OPA Review of NREL LA100: Summary

OPA/RPA Review of NREL's LA100 Study

Review of the LA100 Study - Digest

The Los Angeles 100% Renewable Energy Study

Costs by Pathways - 1/2

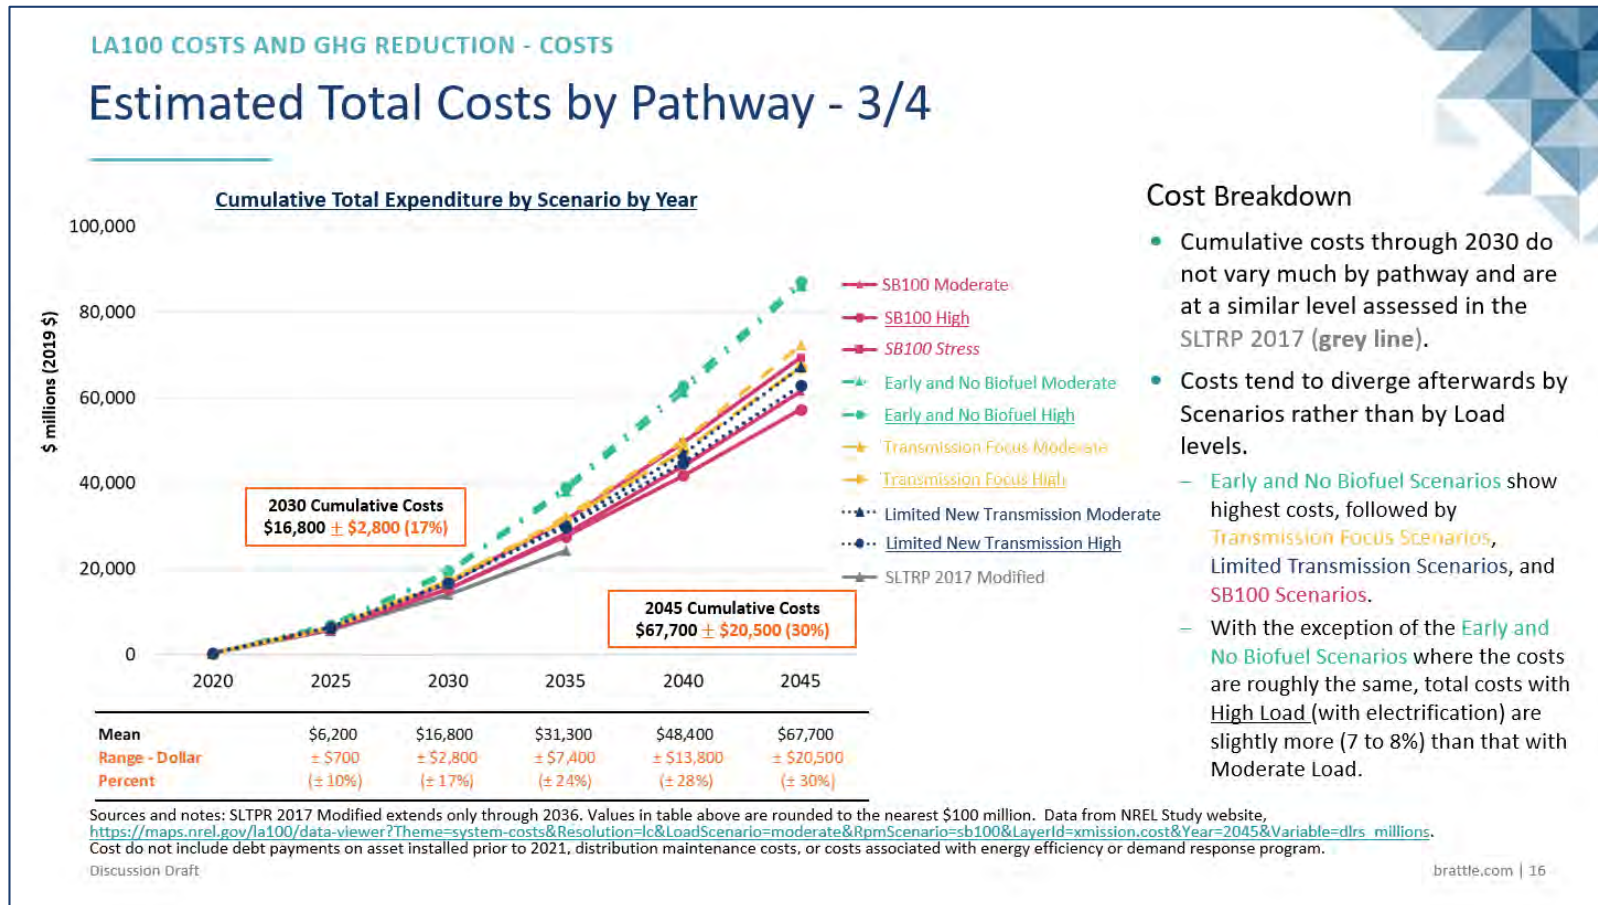
- **Costs grow exponentially in future years (after 2030).**
 - <25% through 2030, <50% (2x of costs through 2030) through 2035. More than half of all costs in the last ten years (2035-2045).

Benefits of Electrification - 1/2

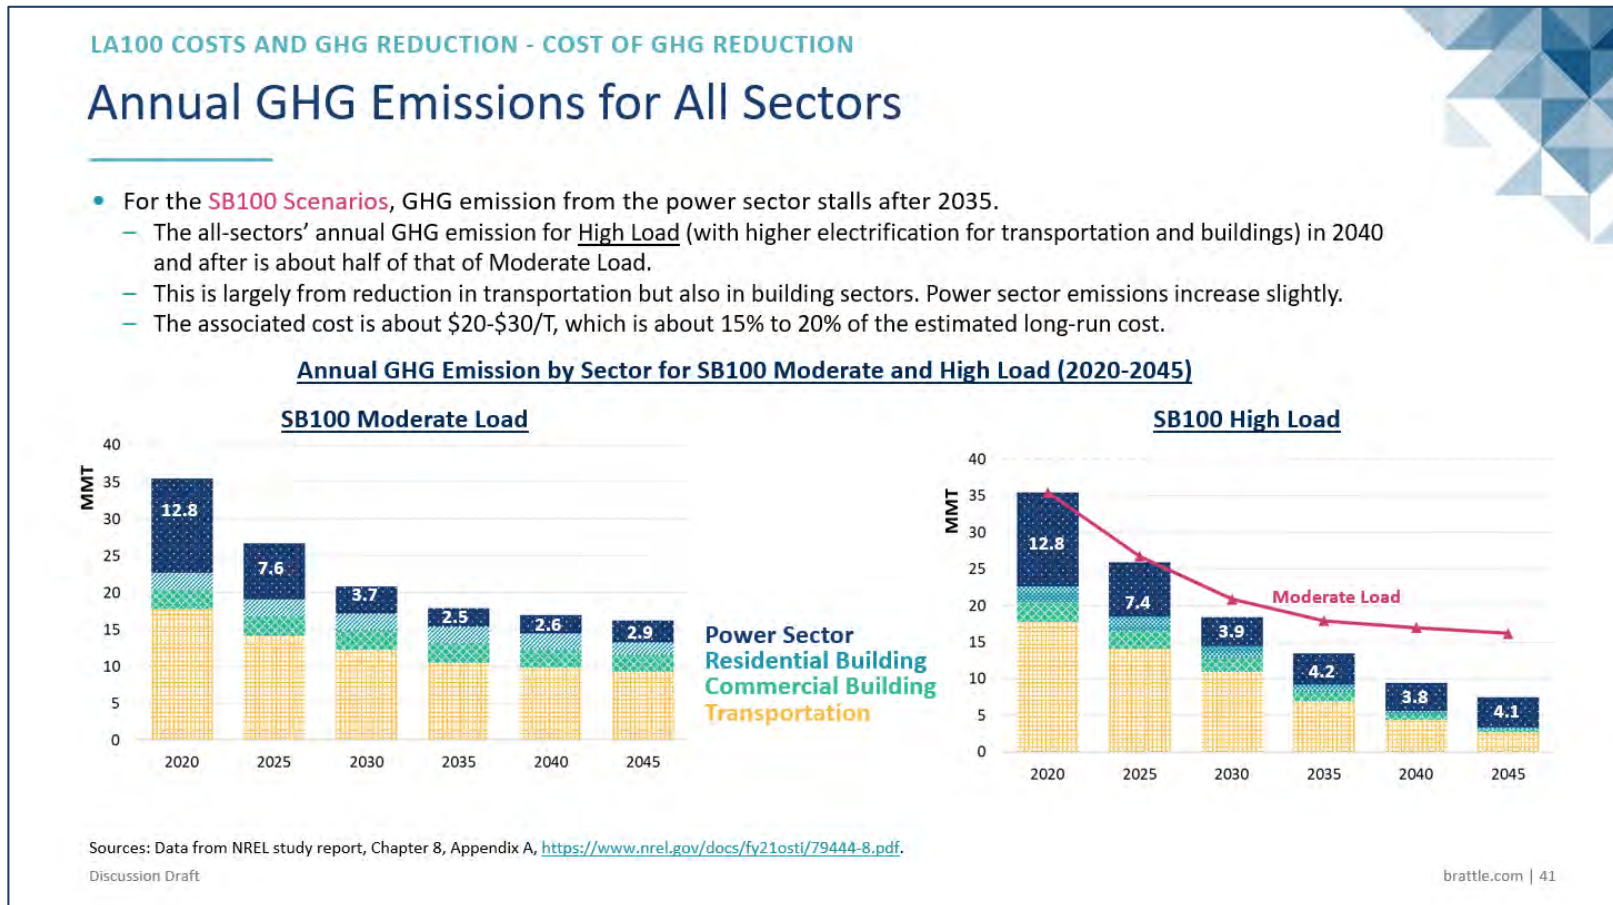
- **Electrification of other sectors reduce more GHG for lower incremental costs.**
 - Study does not account for the cost of electrification but includes the cost of serving the newly electrified load.

Uncertainties - 1/3

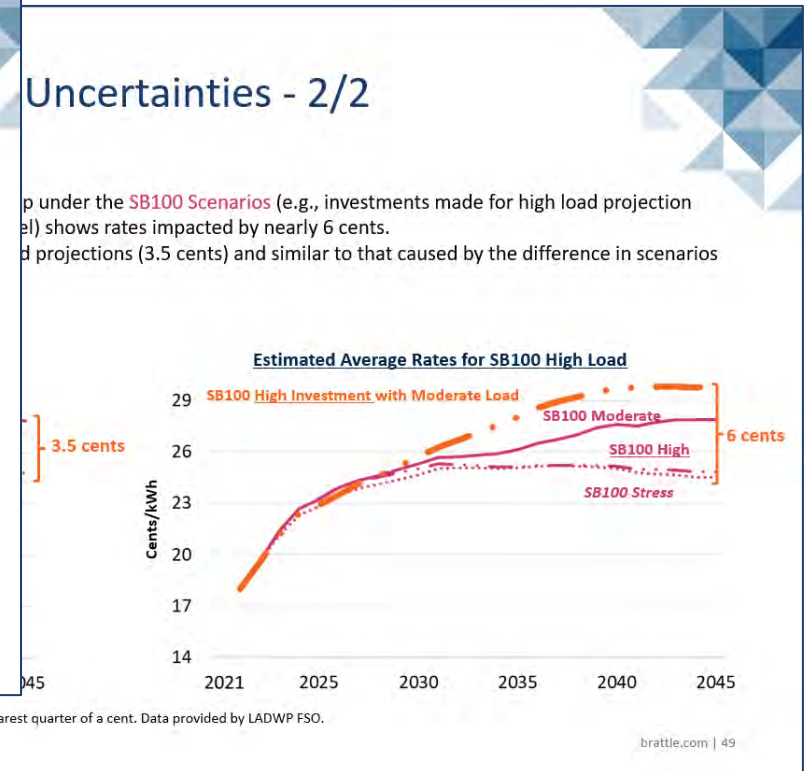
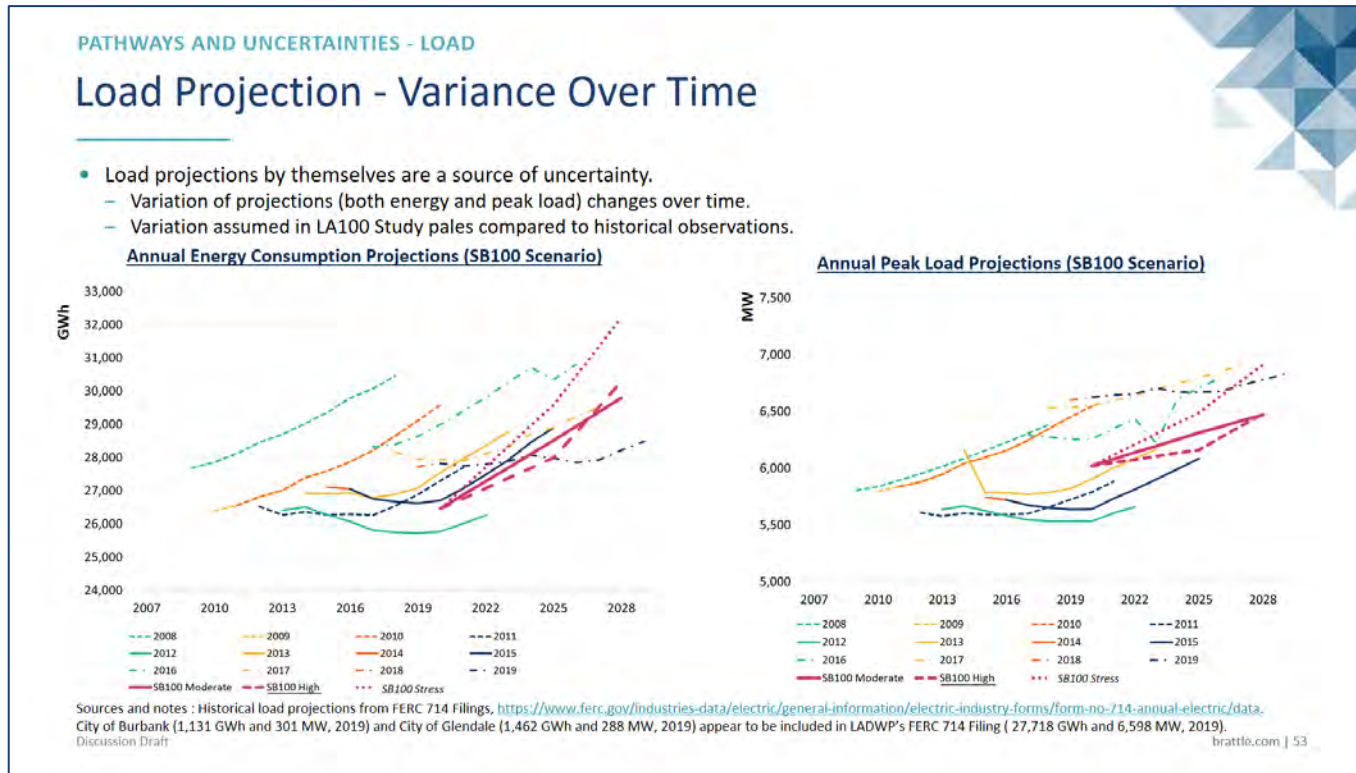
- Load projection has varied year to year, and their accuracy is not guaranteed.
 - Rate uncertainty associated with scenarios and realized loads are of similar levels of magnitude.

Uncertainties - 2/3

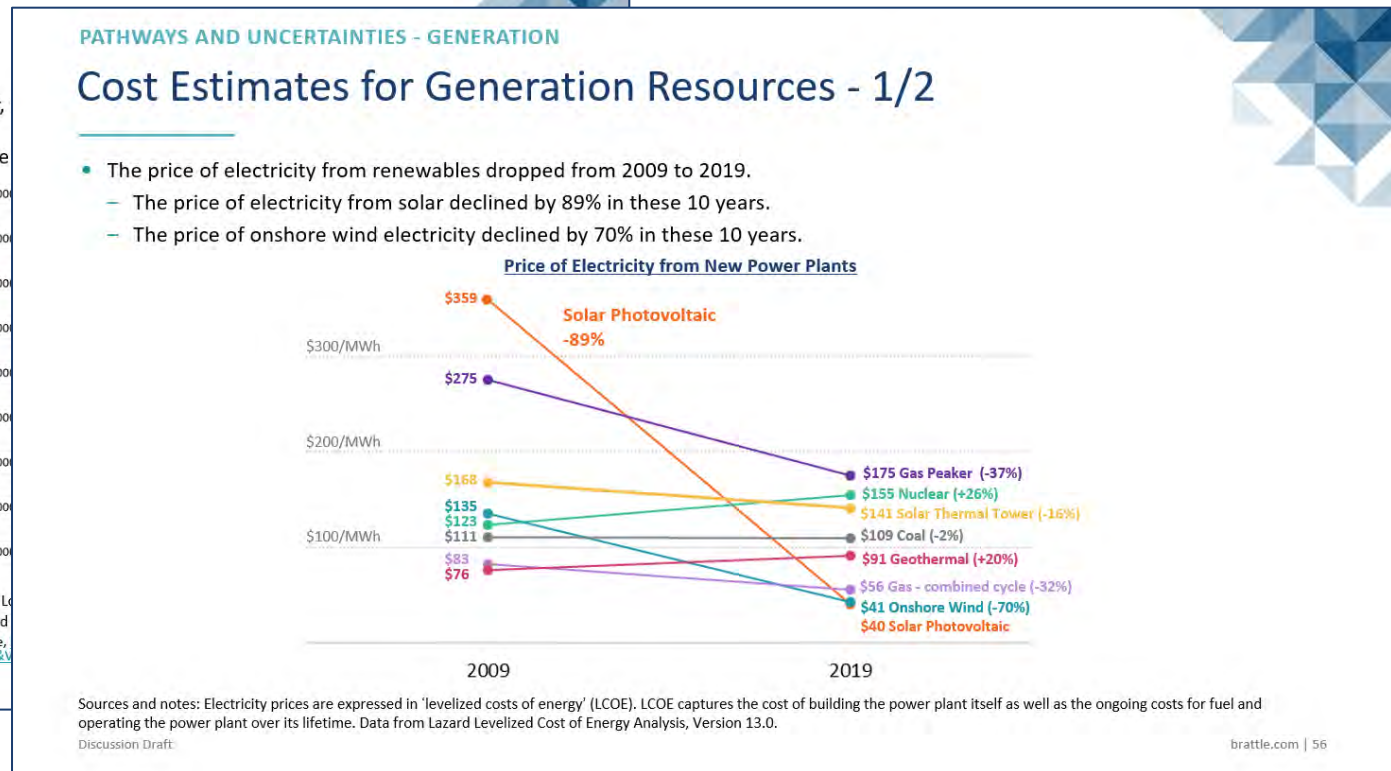
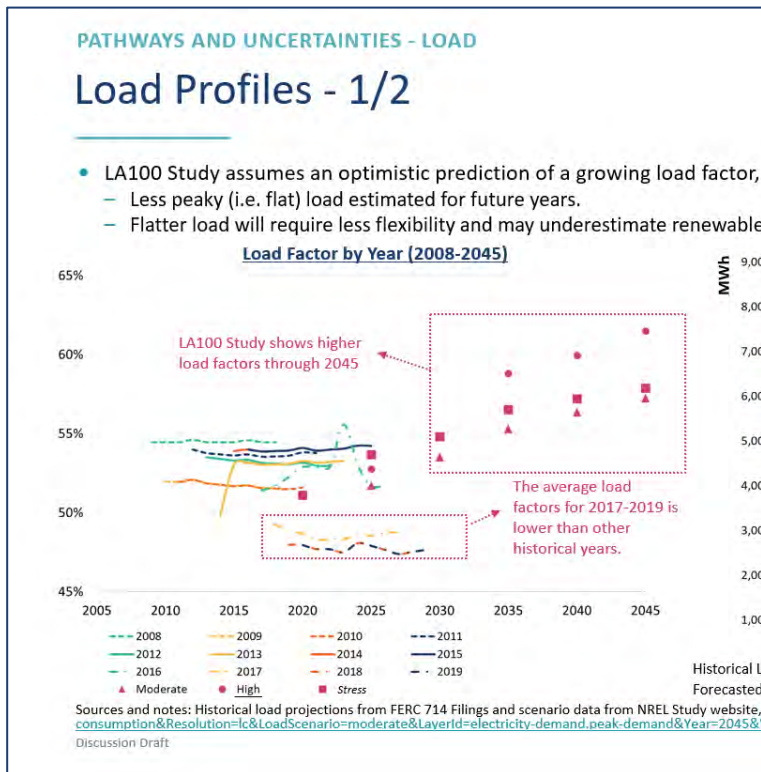
- **Assumptions for load and future generation costs are uncertainties.**

- Load factor (average load / peak load) is higher than historical observations, potentially leading to lower flexibility needs, lower renewable curtailments, and lower cost estimates.

Uncertainties - 3/3

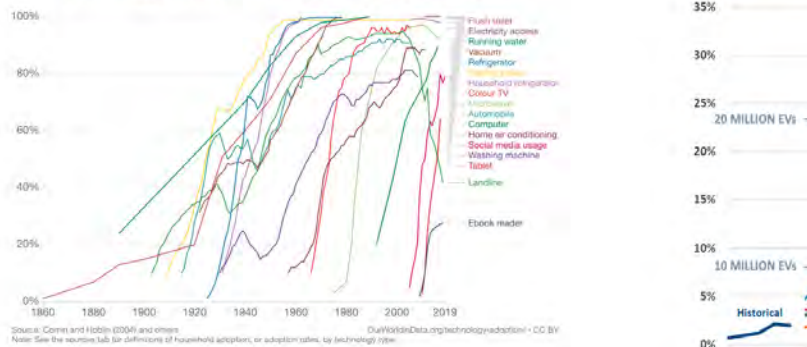
- **Uncertainties associated with timing of investments for future generation.**
 - Adoption rate and timing of new technologies, including electrification (of building and transportation sectors) and distributed energy resources by customers, will impact LADWP’s planning.

Benefits of Electrification - 2/2

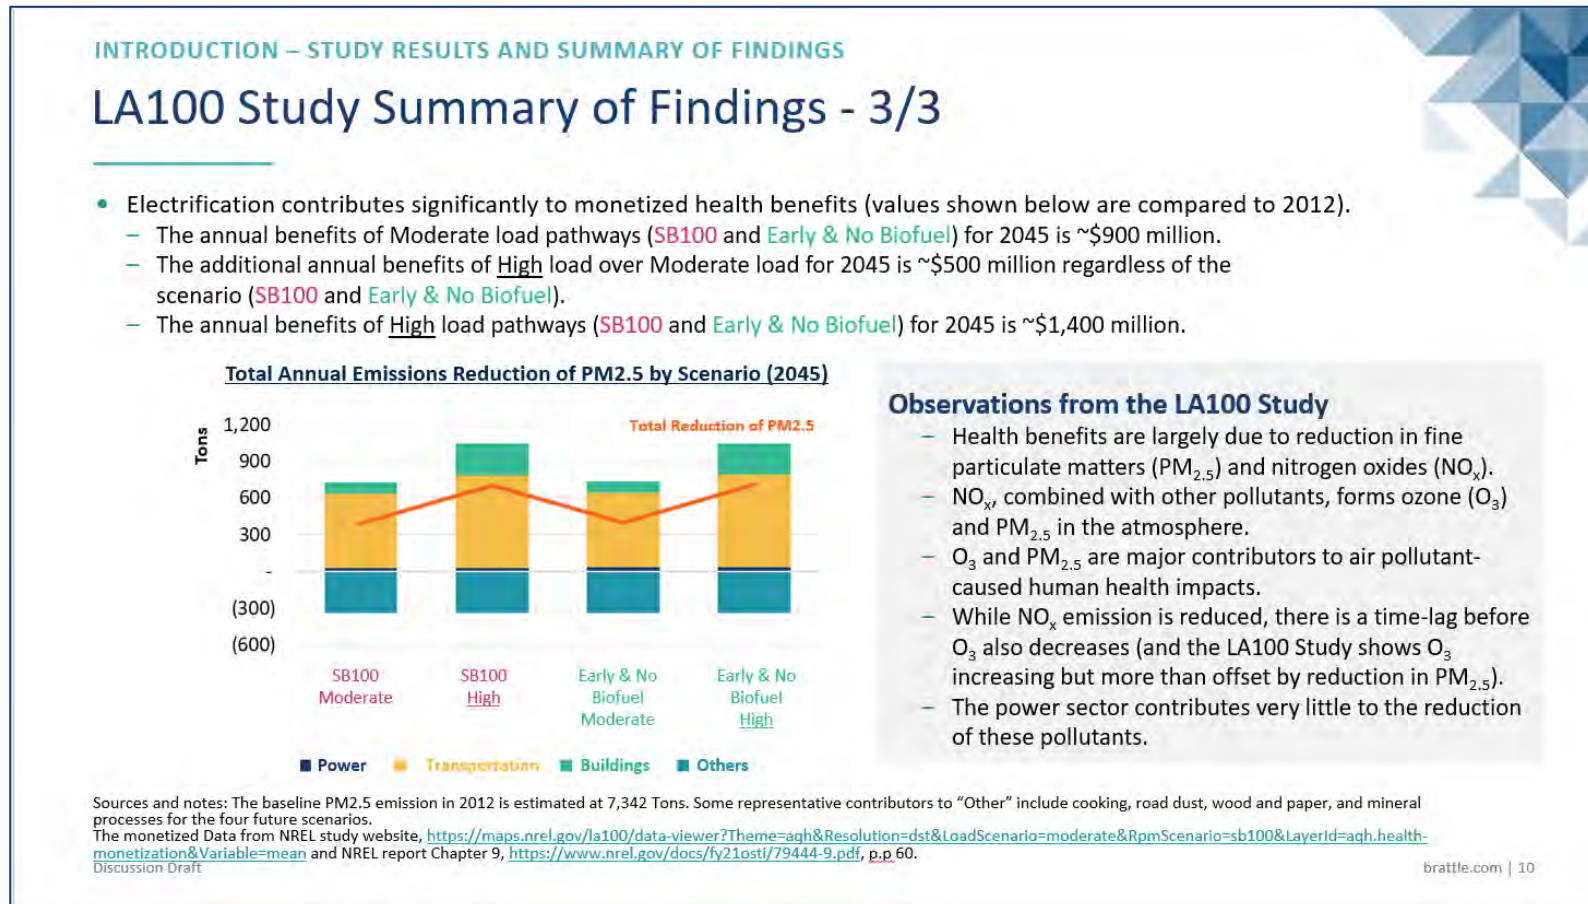
- **Health benefits are correlated more with electrification levels than scenarios.**
 - Higher electrification increases health benefits by more than 50% (and is consistent among scenarios).
